Access Compliance Report Public Rights-of-Way (Curb Ramps)

Main Street: RADIANCE_LN		Cross Street: DANCING_CLOUD_CT		Location: NW
ADA ID: RPRK211019180433	Ramp Type: Type 4 - Parallel	Initial Pass/Fail: Fail	Overall Compliance: No	Severity Score: 2

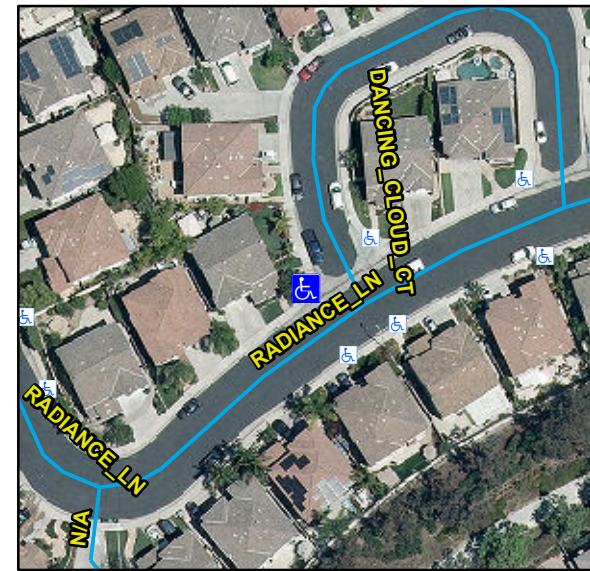
R304.2.2, R204.3, R304.5.3, STD 1115

Remove & Replace Curb Ramp With Two New Directional Ramps or Equivalent.
